# Access Compliance Report

### (Curb Ramps)

Intersection ID: 48604	Main Street: S_TRYON_ST	Cross Street: LITTLE_GEM_LN	Location: NE
ADA ID: F0D853FC1934	Ramp Type: Perp	Initial Pass/Fail: Fail	Overall Compliance: No
Severity Score: 21.25			
Codes/Mitigation Info/Possible Solution		Field Measurements/Component Compliance

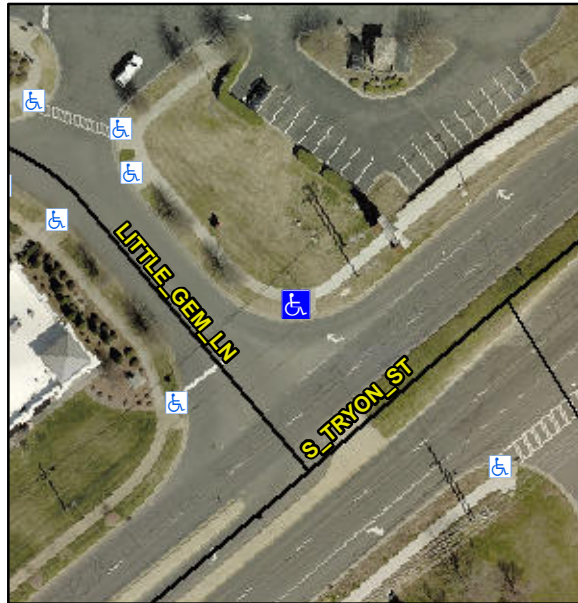
**Remove & Replace Entire Ramp.**

**R304.5.1, R304.2.2**

Compliance	Description	Data	Compliance	Description	Data
N/A	Ramp Length (in)	98.0	No	Ramp Slope (%)	9.0
No	Ramp Width (in)	46.0	Yes	Ramp XSlope (%)	2.0
N/A	Flare Type LT	N/A	N/A	Flare Type RT	N/A
N/A	Flare Slope LT (%)	N/A	N/A	Flare Slope RT (%)	N/A
N/A	Flare Traversable LT?	N/A	N/A	Flare Traversable RT?	N/A
N/A	Landing Length (in)	N/A	N/A	DWS Provided?	N/A
N/A	Landing Width (in)	N/A	N/A	DWS Contrast?	N/A
N/A	Landing Slope (%)	N/A	N/A	DWS Length (in)	N/A
N/A	Landing X Slope (%)	N/A	N/A	DWS Full Width?	N/A
N/A	Landing Curb? (Y/N)	N/A	N/A	DWS Offset (in)	N/A
N/A	Shared Landing?	N/A			
N/A	Gutter Ponding?	N/A	N/A	Gutter Slope (%)	N/A
N/A	Gutter Lip Ht (in)	N/A	N/A	Gutter X Slope (%)	N/A
N/A	Painted X Walk1?	No	N/A	Painted X Walk2?	N/A
	X Walk 1 Direction	To SW		X Walk 2 Direction	N/A
N/A	X Walk 1 Width (in)	N/A	N/A	X Walk 2 Width (in)	N/A
	X Walk 1 Slope (%)	0.7		X Walk 2 Slope (%)	N/A
	X Walk 1 X Slope (%)	3.0		X Walk 2 X Slope (%)	N/A
